DSO80804B-07 E R V I C E N O T E

DSO80804B Digitizing Oscilloscope

M880 Motherboard Upgrade Procedure.

Figure 3

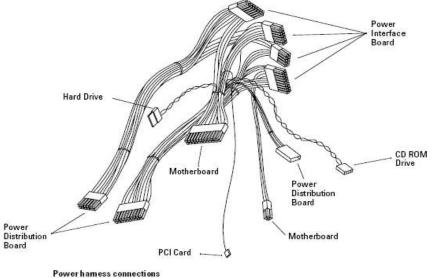
On models 80000B models only the power cable is changed.

Remove the Power cable D8104-61601install new power cable D8104-61606.

Figure 16

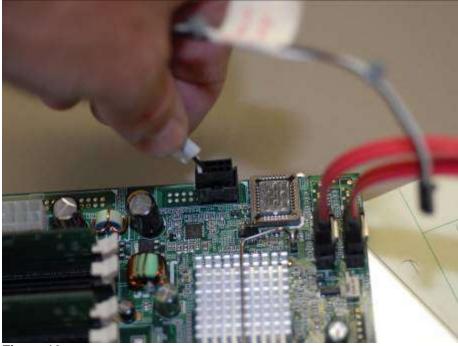
30 Using new Heat Sink and Fan Assembly install fan to Motherboard and Deck. (See Figure 16) Connect fan power cable to fan CPU Fan jack. Torgue fan screws to 5 in-lb.

31 Using new Motherboard Switch Cable 54855-61628 connect to motherboard assembly. (See Figure 16)

Note: Do not use thermal grease on Heat Sink/Fan assembly. It comes with its own thermal type material.

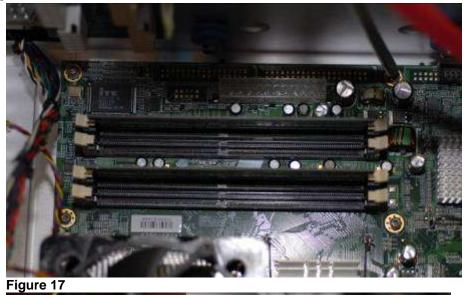
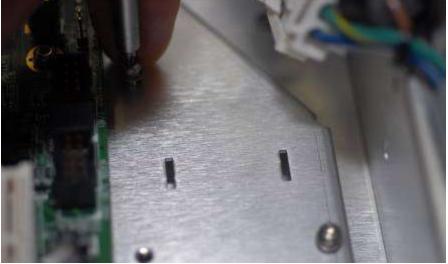
a Install the 3 long Torx T10 screws and two short T10 into the tray holding the motherboard assembly to the frame chassis. (See Figure 17 and 18)

Figure 19

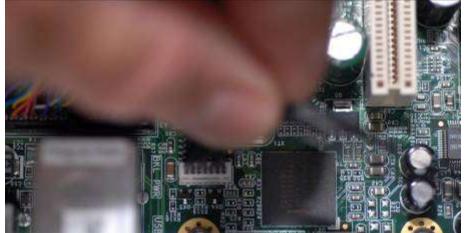
a Connect new display cable to motherboard. (See Figure 19)
b Connect the two USB cables (See Figure 20)
c. Connect motherboard Switch cable to PCI card (See Figure 21)
